**ADVISORY BOARD ON
RADIATION AND WORKER HEALTH**
National Institute of Occupational Safety and Health

**Review of NIOSH Site Profile
for
Savannah River Site**

SCA-TR-TASK1-0003

March 21, 2005

Figure 5.2 Variation of the Backscatter Factor with the Quality of the Radiation for a Number of Field Sizes
(Source: Hine and Brownell 1956)

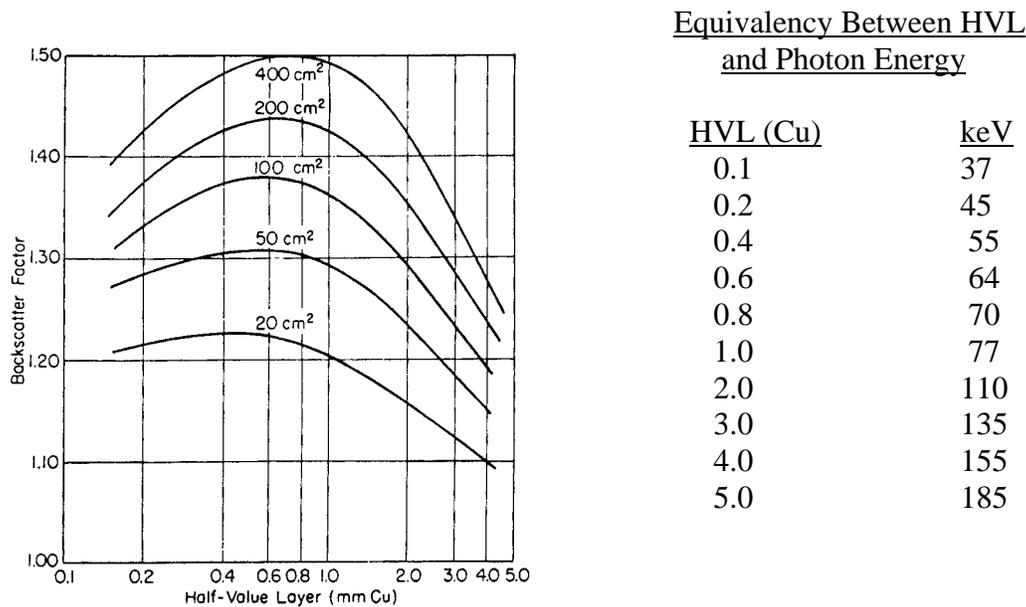
From data presented in Figure 5.2, it is likely that the cited on-phantom correction factor of 1.119 may be too low for photon energies between 30 and 250 keV.

Figure 5.3 Trends in SRS and Hanford Collective Neutron Dose Normalized to Plutonium Production

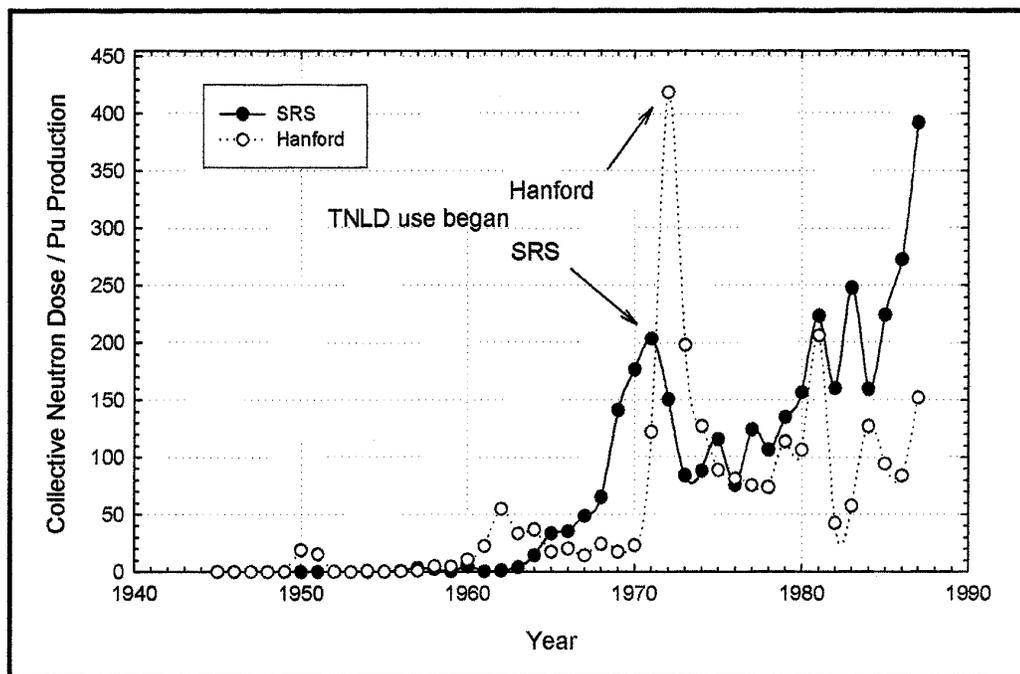
evident in this figure that the collective neutron dose was under-recorded prior to implementation on 1 January 1971 of the SRS TLND and 1 January 1972 for the Hanford TLD. The extent of the under-estimate is difficult to estimate. SRS and Hanford showed a significant increase in the ratio of the annual collective neutron dose to the annual plutonium production when the TLD neutron dosimeters were implemented. [Emphasis added.]

The above referenced Figure 5.3.4.2-2 is reproduced below as Figure 5.3. Neither statement (as emphasized above) is supported by data shown in Figure 5.3:

- At both SRS and Hanford, the rise in collective dose (supposedly standardized to plutonium production) began well before the advent of the TLND; and, in both cases, the standardized collective dose dropped precipitously after the implementation of the TLND with subsequent fluctuations.
- Because the collective neutron doses were **standardized** (i.e., defined in person-rem per unit quantity of Pu), the observed oscillations clearly indicate that the collective dose is **not** correlated with or linked to plutonium production, but may very well be the result of variations in neutron fields that surround work conditions in a given area and the variable response of the TLND.
